28F400BV/CV/CE 28F004BV/BE SPECIFICATION UPDATE

Release Date: February 1997

Order Number: 297595-013

Timing Waveform for WE#-Controlled Writes

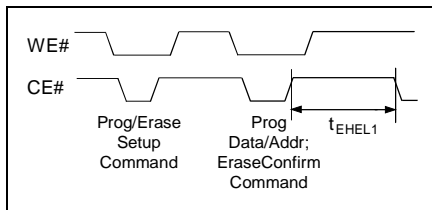
WORKAROUND:
A. t_{WHEH} - CE# Timing Erratum

Due to a logic timing problem, new timing restrictions may be necessary between the WE# and CE# signals during write operations. The timing waveforms and specifications are shown below:

Symbol	Parameter	Datasheet		Errata		Units
		Min	Max	Min	Max	
t_{WHEH}	CE# Hold Time from WE# High	0	no spec	0	5	ns
t_{WHEL1}	CE# Pulse Width High from WE# High	no spec	no spec	110		ns

Erratum timing for t_{WHEL1} , given above, is required only after the second WE# pulse in a WE# controlled write sequence.

1. Take CE# to logic high no earlier than WE# goes high and no later than 5 ns after WE# goes high.
2. Hold CE# high for at least 110 ns, starting from the time WE# goes high.

These timing specifications must be met for proper operation of the device. The flash memory chip select must go inactive within 5 ns of a program/erase operation and remain inactive for a period of 110 ns before going active again. Consider the following options for meeting the t_{WHEL1} or t_{EHEL1} requirement:

1. Follow a program/erase two-write sequence with an access to another memory so as not to decode the flash memory chip select for the required period of time.
2. Insert one or more no-op commands following a program/erase two-write sequence, again to ensure the flash memory chip select is disabled for the required period of time.
